File Ref: PRE2023/0043

**Property:** 7-9 Brighton Road, Peakhurst and 21 Charles Street, Riverwood  
**Proposal:** Demolition of 3 existing dwellings and associated structures, and the construction of a 14 dwelling seniors housing development containing 6 x 1-bedroom and 8 x 2-bedroom independent living units, associated landscaping and fencing, parking for 7 cars, and consolidation into a single lot.

**Subject:** Proposed seniors housing development

Figure 01 – Proposed excavation along the Southern Boundary

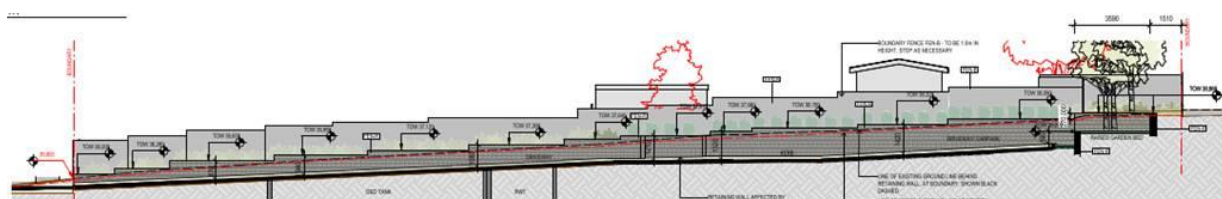
In addition, excavation is also proposed along the southern boundary and the driveway off Brighton Road located around 1.4m below the existing natural ground requiring a 1.5m high retaining wall. This is considered entirely unnecessary (Refer Figure 01). Excavation to a depth of 2.7m is also proposed to accommodate a rainwater tank (RWT) and ODS, which is considered appropriate (Refer Figure 2).

Part 3.5.1 of GRDCP requires developments to not alter natural or existing ground levels by more than 1m in low density areas. The objective is to *ensure that the natural topography and landform is maintained, and the amount of excavation is minimised*.

The proposal does not comply with the GRDCP requirements. It is considered that the split level / lowering of the Ground Lower is proposed not to address existing topography but for the proposal to comply with the maximum permitted building height. The proposed excavation is not considered an appropriate response to the existing topography and inconsistent with the GRDCP objectives. Hence, the extend of the proposed excavation for the driveway and the units is not supported.

**It is recommended** that the proposal should be amended to provide an appropriate response to the existing topography. Steps are a barrier to visual and physical engagement with the public domain, car parking and open space. Hence, the design should be amended for the proposed ground floor FFLs to be relative to the existing topography and the habitable areas above the existing natural ground to provide the required amenity. The building should be designed to minimise the number of steps across the site. The driveway should also be located above the natural ground with gradual gradients to address the slope.

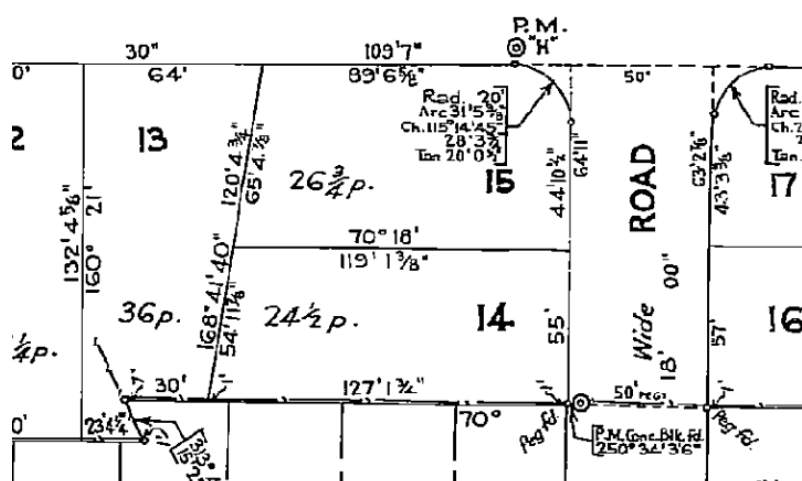
Sheets 1 and 2 of the “Detail & Contour Survey” prepared by TSS (Ref 220469 dated 26/05/2022) do not show the correct property boundaries for corner lot 15 (No. 9 Brighton Road) at the intersection of Charles Street and Brighton Road.

At "NOTE" in the top left corner of sheet 1 it states regarding boundary information that "...the location of property boundaries has been taken from the titled deposited plan".

Deposited Plan DP 35818 for corner lot 15 shows it has a 6.1m (20 foot) radius at the intersection of Charles Street and Brighton Road and not a straight boundary line as shown on the survey and architectural plans- see the extract below from Council's records relating to lot 15 DP 35818.

It is assumed in the consolidation of the 3 lots into 1 that the applicant is proposing to delete the curve and replace it with the straight boundary line however the survey plan showing what is understood to be existing boundaries should show them as per the DP.

**COMMENT:** It is considered the survey plan should be amended to reflect correct boundary lines for Lot 15 and correct site areas for lots 14 and 15.

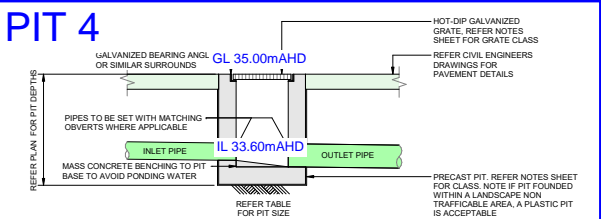
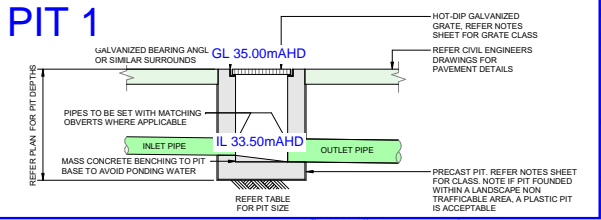
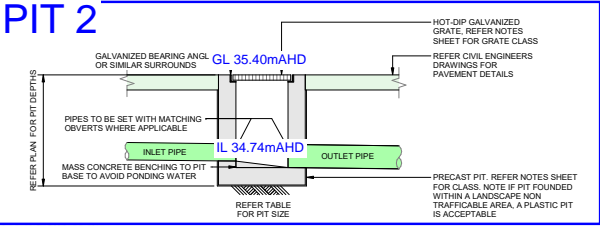
1 THESE COMMENTS CONFIRM THE GRATE LEVELS (GLs) AND INVERT LEVELS (ILs) OF OUR PROPOSED PITS - SEE IMAGES FOR CLARITY. CRITICAL ITEM IS THAT THEY ALL FALL TO FINAL PIT 1 (WHICH THEY DO AS CAN BE SEEN)

2 THIS COMMENT IS QUESTIONING THE INVERT LEVEL AS IT IS NOT PROVIDED. WE CONFIRM THAT THE INVERT LEVEL HAS BEEN SHOWN ON THE UPDATE PLAN DATED 01.11.2023 AND ACHIEVES GRAVITY FALL TO PIT 4

SCREENSHOT FROM REVISED PLANS

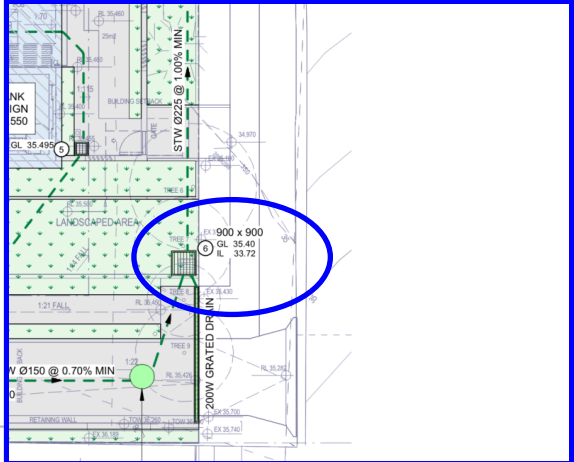
6 SIMILAR TO COMMENT 3. COUNCIL ARE JUST VERIFYING THE OSD VOLUME WORKS. WE NOTE IN THE LATEST REVISION, THE TWL IS TOP WATER LEVEL WHICH REDUCED AS THE DRIVEWAY IS SLOPING HOWEVER VOLUME IS STILL ACHIEVED. WE ACHIEVE 48m³ AND THE MINIMUM IS 40m³  
AVERAGE DEPTH = 1.66m x PLAN AREA = 29.4m² = VOLUME = 48.8m³

TYPICAL CONCRETE INLET PIT - CONCRETE SURFACE  
Scale: 1:20

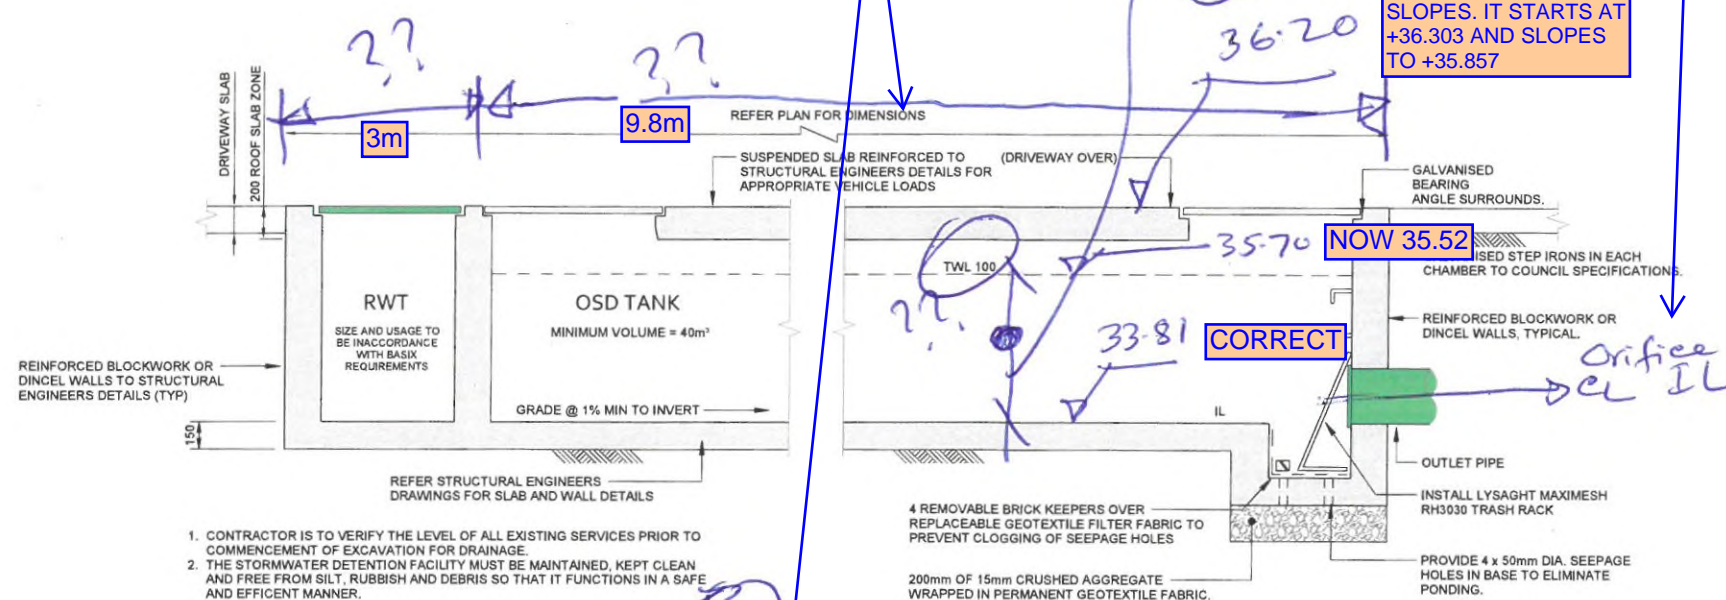
SIMILAR TO COMMENTS 3 AND 6 SPECIFIC SECTION. THIS SHOULD NOT HOLD PART 5 AS VOLUME OF OSD IS ACHIEVED AND THIS DETAILING CAN BE CAPTURED IN STAGE D.

ON SITE DETENTION TANK DETAIL - DRIVEWAY AREA WITH ORIFICE PLATE  
Scale: 1:20

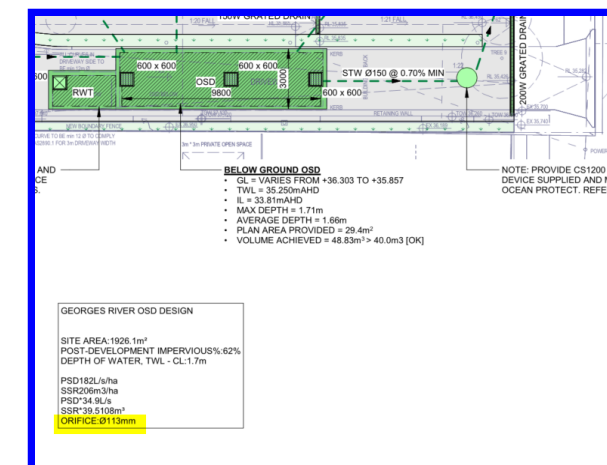
THE ORIFICE HAS BEEN NOTED IN THE REVISED PLAN.

Figure B - TREE 2 (T2) and the proposed new retaining wall and driveway

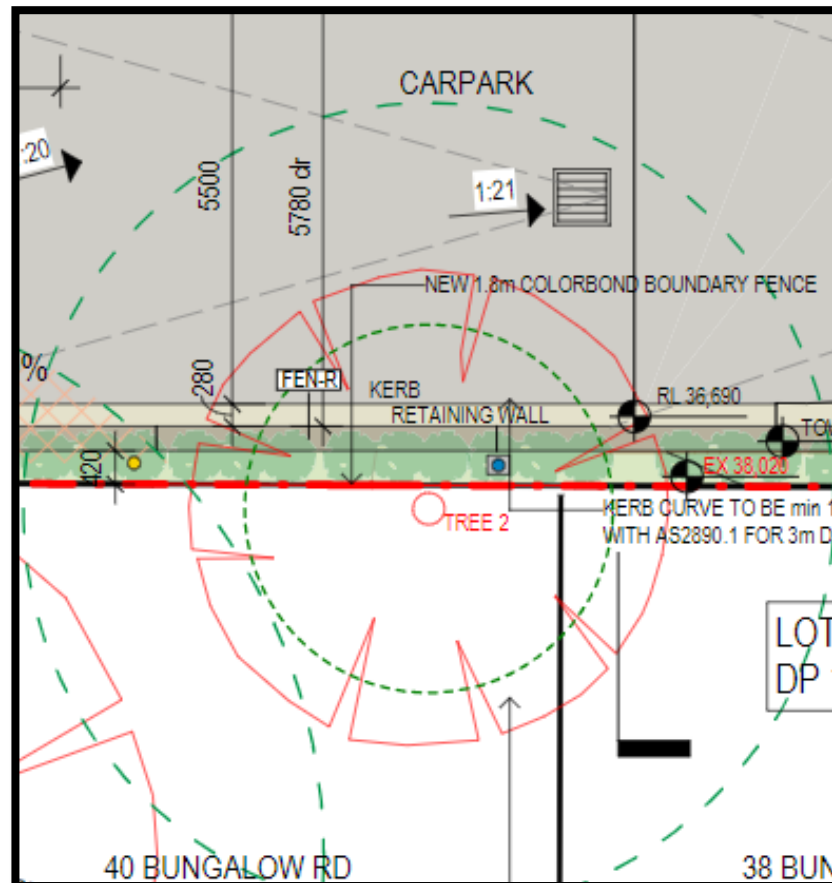
As the registered property owners of **40 Bungalow Road, Peakhurst**, we are seeking your consent for the removal of the Broad-leaf Privet tree, at the rear of your property, identified as TREE 2 (T2) on the enclosed aerial photograph (**Figure A**). The root system of T2 extends into the area of excavation required to construct a new retaining wall and driveway for the development, as shown on the enclosed diagram (**Figure B**). A consultant Arborist has advised LAHC that were the retaining wall and driveway to be constructed as proposed, the tree would be destabilised to such an extent that it would likely not survive.
